UTT/21/2509/OP Land South Of (East Of Griffin Place), Radwinter Road, Swards End, Essex

Outline application for the erection of up to 233 residential dwellings including affordable housing, with public open space, landscaping, sustainable drainage system (SuDS) and associated works, with vehicular access point from Radwinter Road. All matters reserved except for means of access.

Objection

Saffron Walden Town Council and Swards End Parish Council response to Scoping

Fuel Storage and Pipes

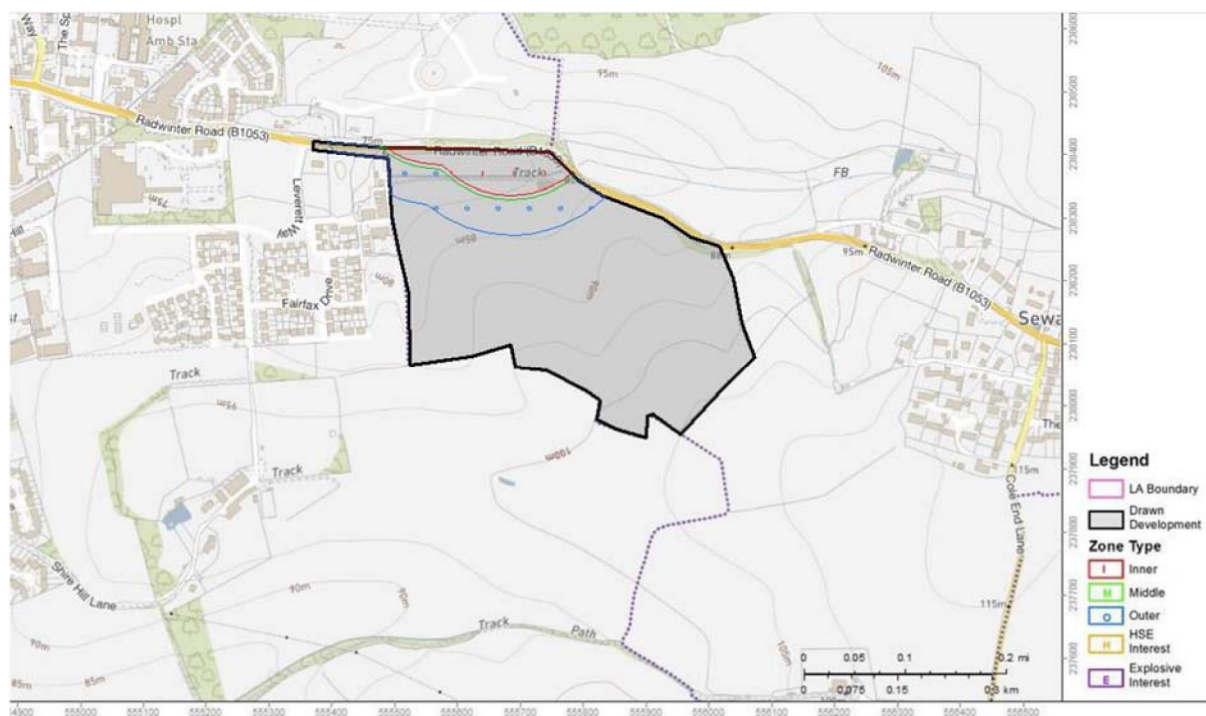
The site is compromised for housing because housing is a vulnerable use, the proposed location is next to an aviation fuel store, and fuel and gas mains pipes run below the Site.

The Parameter plans propose development within exclusion buffer zones. The only means of vehicular and pedestrian access are within the aviation fuel store exclusion zone.

Viewpoints and LVIA

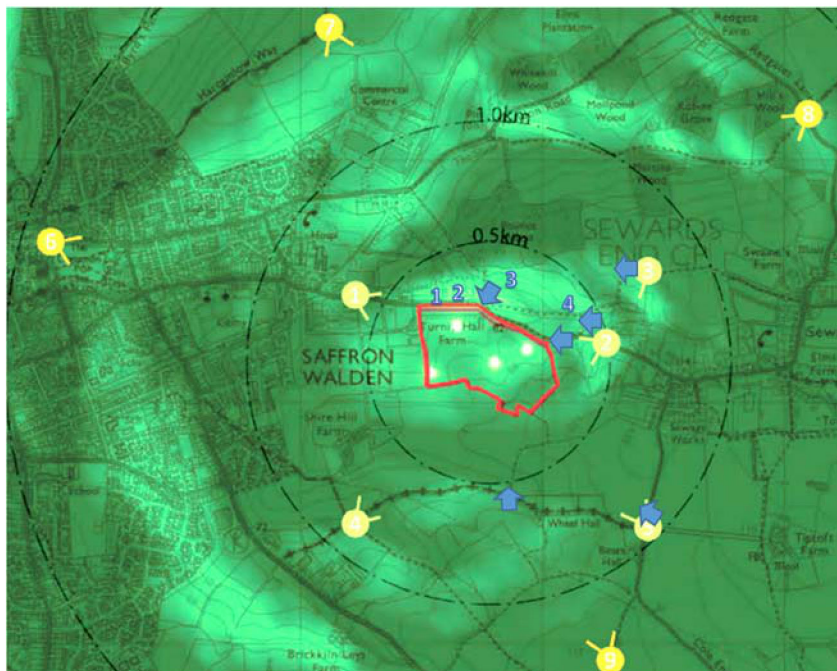
The Viewpoints do not address the joint Councils' response and Holding Objection at Scoping stage:

1. The selection does not show a representative group of views. It omits key views such as from the existing site entrance looking into the development.
2. The lighting positions used to establish the extent of visibility crucially do not include the highest part of the Site (which is likely to be the most prominent).
3. The views were plotted onto a map which indicated areas of intervisibility as lit areas. Some viewpoints (such as 4) appear to be taken from unlit locations, when there are lit locations close-by.
4. Some viewpoints have been taken from behind obstructions when it is likely that the view could be adjusted to show an adjacent more informative view.

The joint Councils' proposed revised and additional viewpoints all identified at Scoping stage are included on the map below in blue. Those arrows close to the Scoping arrows are where it is considered that the LVIA should be extended to show an adjacent more informative view and/or to avoid obstructions in the foreground. .
